PRODUCT SUPPORT BULLETIN # 318

120VAC - 6072, 6075, 6076, 6078 13AMP SANDER/GRINDERS
6065, 6066, 6067, 6068, 6070, 6095, 6096, 6098 7"/9" 15AMP SANDER/GRINDER

SUBJECT: SERVICE NOTES - GEAR TRAIN SLIPPAGE
06-57-0500 1/4"-28 LOCK NUT

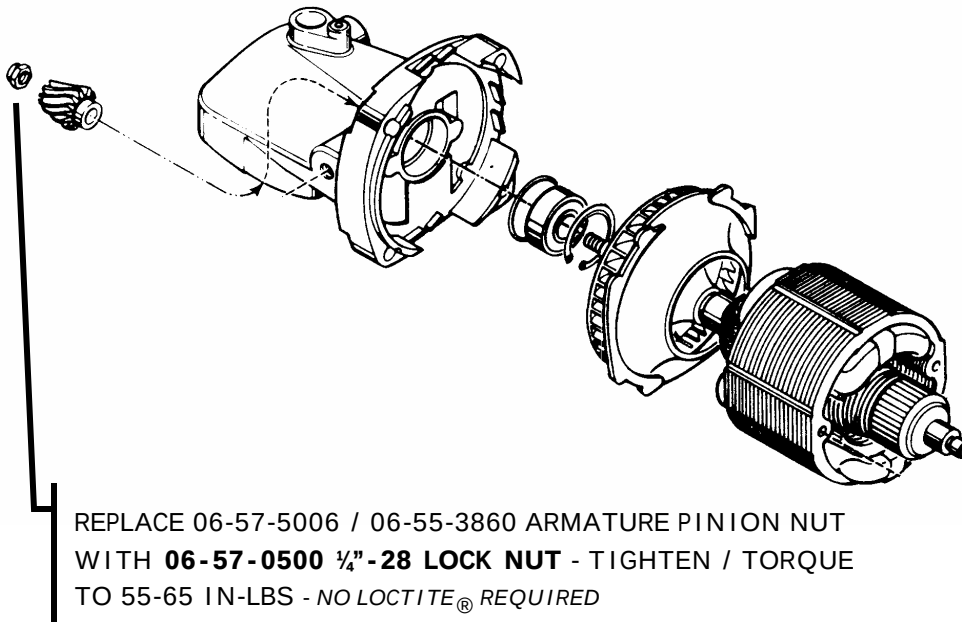
IMPORTANT! THIS SERVICE BULLETIN COVERS ALL 7" & 9", 13 & 15 AMP SANDER/GRINDERS USING EITHER THE **16-50-1185** OR **16-70-0300** 120 VOLT ARMATURE AND 06-57-5006 / 06-55-3860* 1/4"-28 ARMATURE PINION HEX NUT (*see TO INFORM YOU / PRODUCT SUPPORT BULLETIN # 298 and # 314).

06-57-0500 1/4"-28 LOCK NUT IS A NEW SERVICE REPLACEMENT PART THAT SHOULD BE SUBSTITUTED FOR THE ORIGINAL EQUIPMENT (06-57-5006 / 06-55-3860* 1/4"-28 ARMATURE PINION HEX NUT) DURING SERVICE AND RE-ASSEMBLY OF THE TOOL. 06-57-0500 1/4"-28 LOCK NUT SHOULD BE TIGHTENED TO 55-65 IN-LBS. OF TORQUE

INVENTORY OF 06-55-3860* 1/4"-28 ARMATURE PINION HEX NUT SHOULD BE SCRAPPED.
